SUBJECT: Transmittal of Revised Responses to AP1000 DSER Open Items

**AP1000 Design Certification Review
Draft Safety Evaluation Report Open Item Non-Proprietary Responses**

DSER Open Item Number: 21.5-1 Item ADS4 K Sensitivity

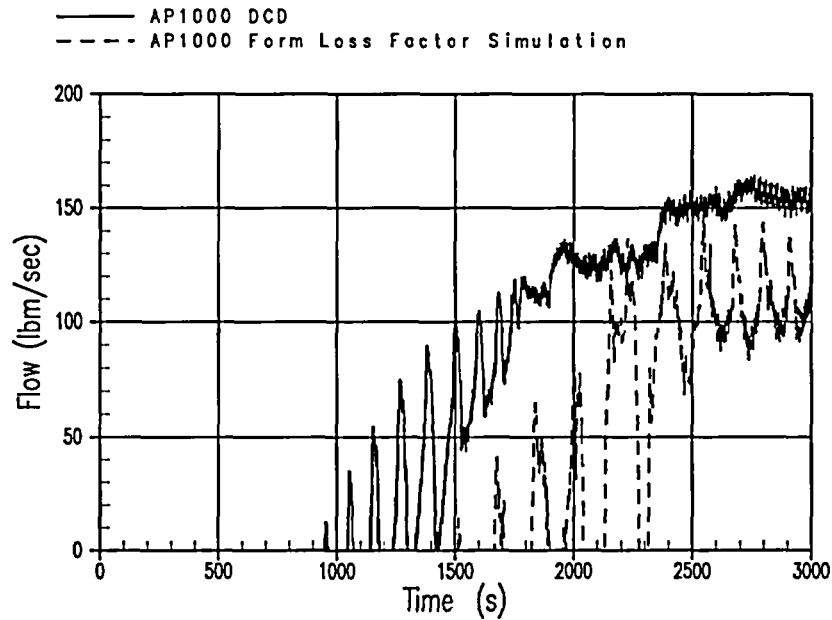
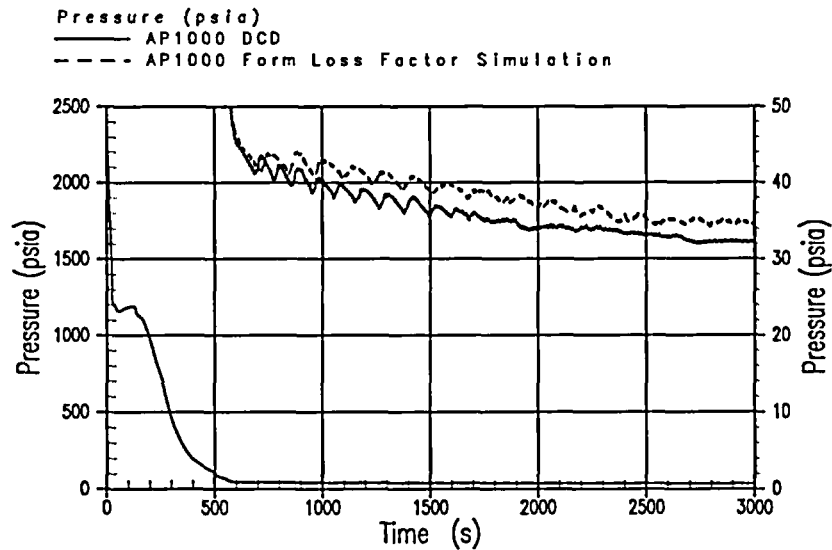
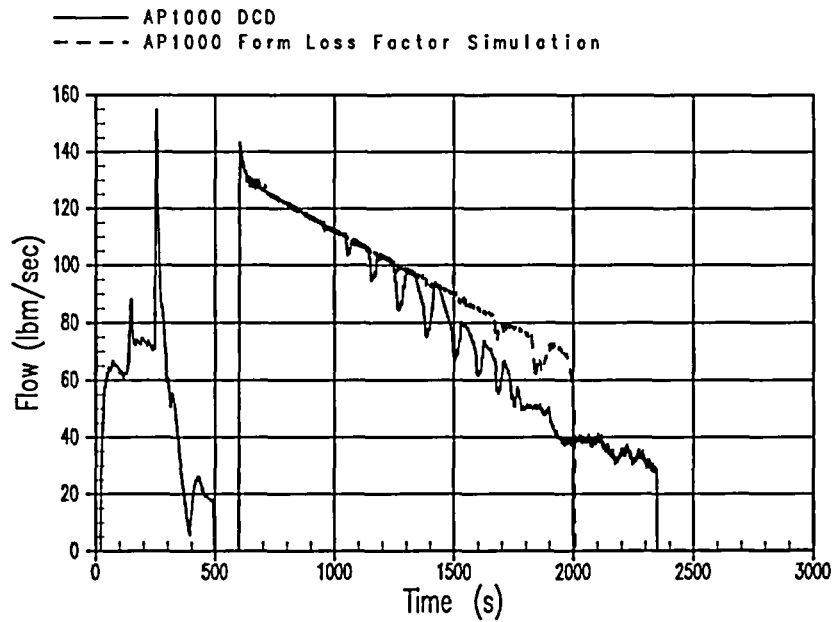
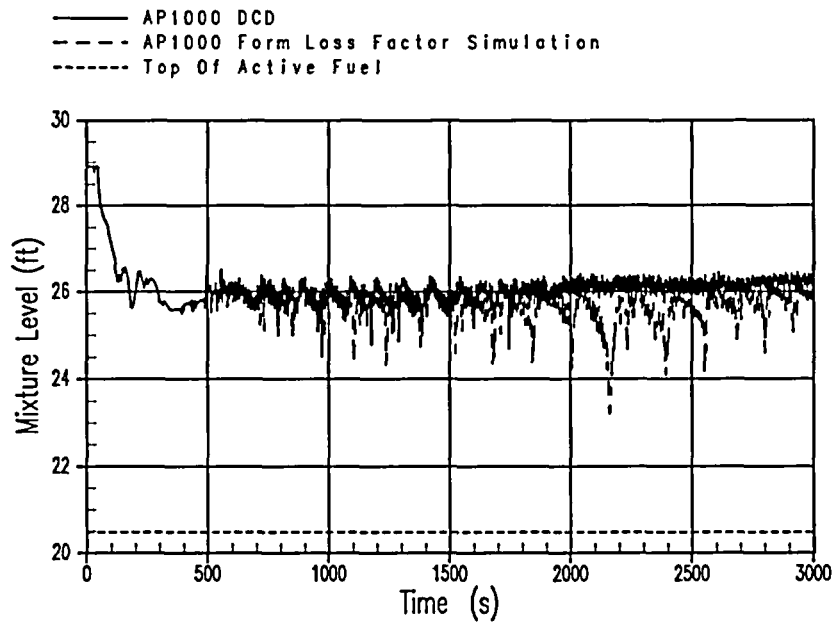
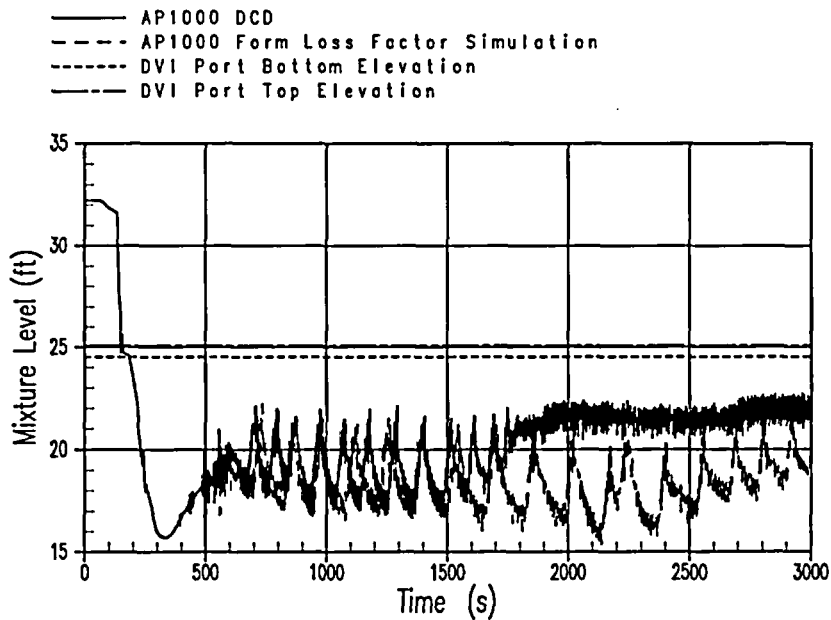
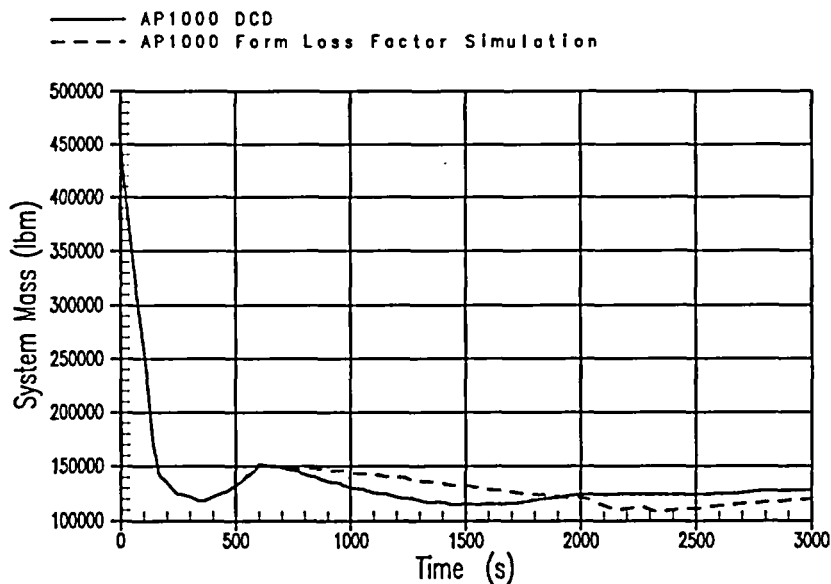
In the October 2, 2003, NRC / Westinghouse meeting on AP1000 thermal/hydraulic open items the NRC requested NOTRUMP (SBLOCA) and WCOBRA/TRAC (LTC) sensitivity analyses to the form loss factors used in modeling the AP1000 ADS4 flow paths.

The NOTRUMP DEDVI, with the adjusted ADS-4 flow paths, simulation was performed in the same fashion as the DCD cases. The event times for this transient are shown in Table-1. The transient results are shown in Figures 1 through 7 for the base DCD case and for the

sensitivity case. The results indicate that the increased ADS4 resistance slows the system depressurization after ADS4 opens and delays the start of IRWST injection. The IRWST is delayed until after the intact CMT has drained. The inner vessel mixture level reaches its minimum just prior to sustained IRWST injection for the sensitivity case but is still well above the top of the core.

The base DCD analysis includes conservatism in the ADS4 form losses in the method used to determine these losses for the ADS4 flow paths. This sensitivity analysis indicates that the DCD analysis is not highly sensitive to the ADS4 flow path form losses.
